SOUTHERN NEVADA AMENDMENTS TO THE 2024 INTERNATIONAL BUILDING CODE

Preface

**FIGURE 1110.4.5.3
SIZE AND MANEUVERING CLEARANCES AT THE ADULT CHANGING SURFACE**

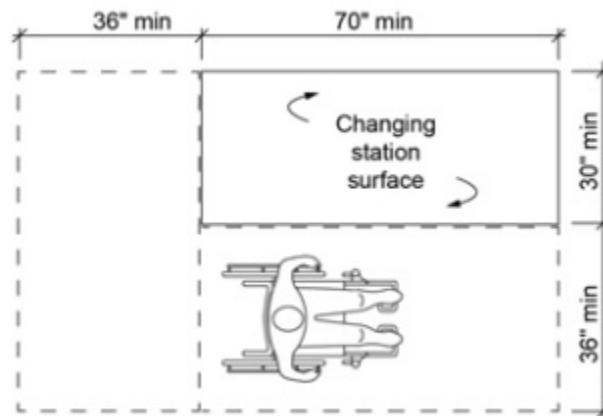
To add installation criteria for adult changing stations as follows:

1110.4.5.3 Changing surface.

A changing surface shall be provided and shall comply with Section 1110.4.5.3.
